PLANT NAME: Oconee 1-3

AMDT to OL/Change to Tech Specs: Consisting of revisions with regard to miscellaneous topics with the intent to update & improve existing tech specs.....

Re: Oconee Nuclear Station  
Docket Nos. 50-269, -270, -287

Pursuant to 10CFR50, §50.90, an amendment to the Oconee Nuclear Station Technical Specifications, Appendix A to Facility Operating Licenses DPR-38, -27, and -55 is requested. These proposed changes concern several miscellaneous topics and are intended to update and improve the Oconee Technical Specifications. Replacement pages for these proposed changes are attached.

OCONEE NUCLEAR STATION  
STATION ORGANIZATION CHART  
FIGURE 6.1-1

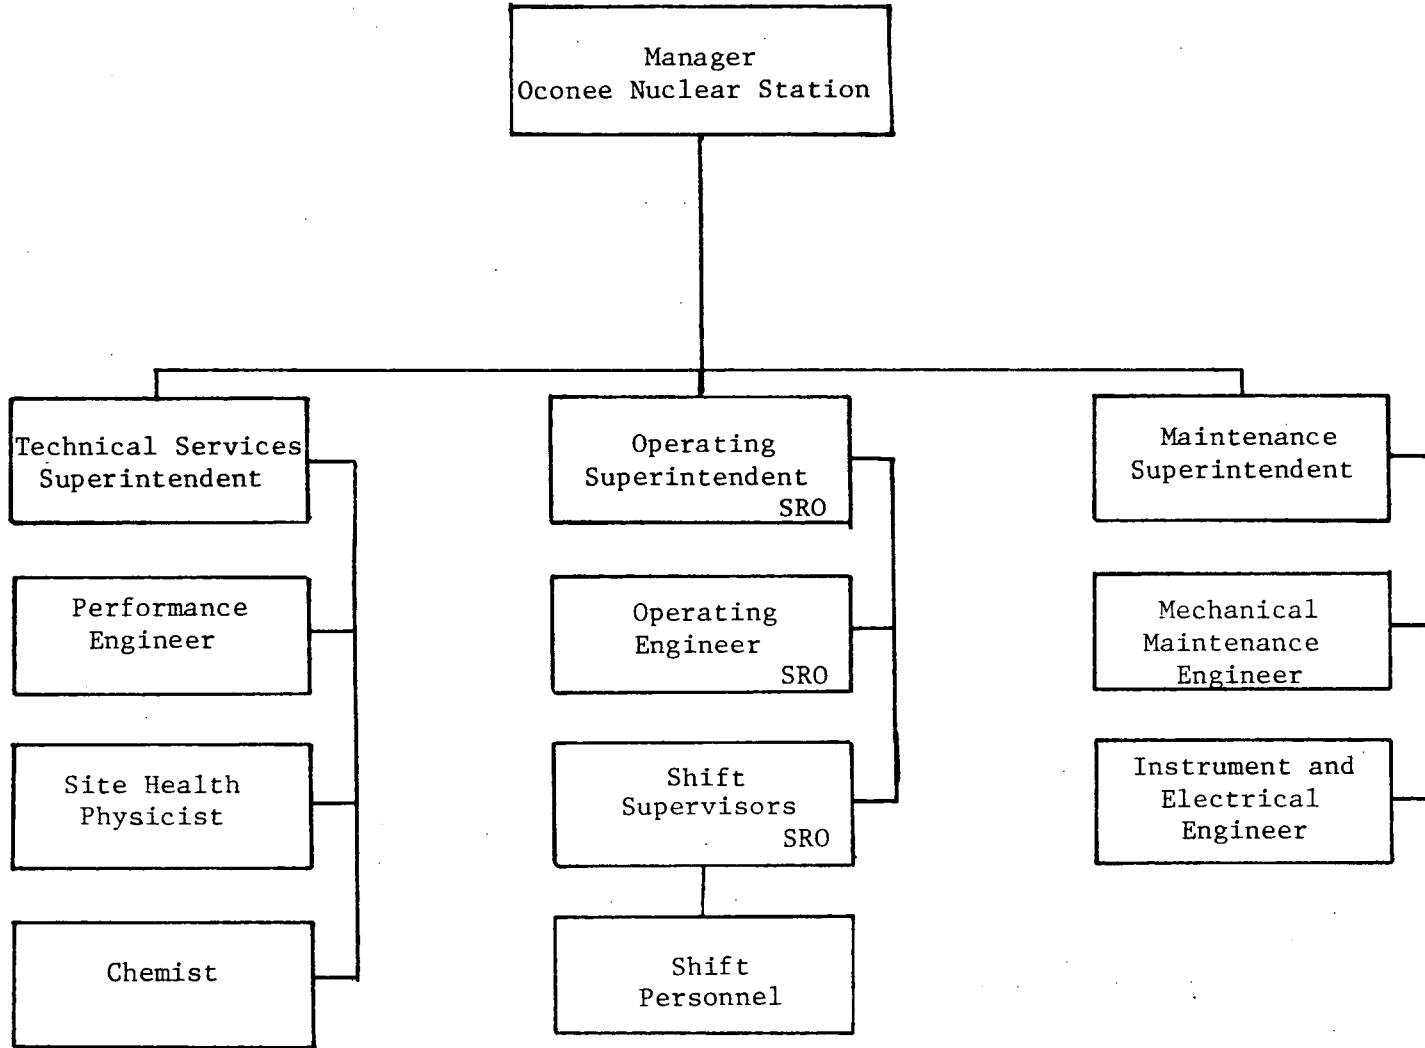
6. Technical Specifications 3.5.2.7, Table 4.11-1, 6.4.1, 6.5.2 and Figure 6.1-1 have been revised as indicated to reflect recent administrative changes and are self explanatory.
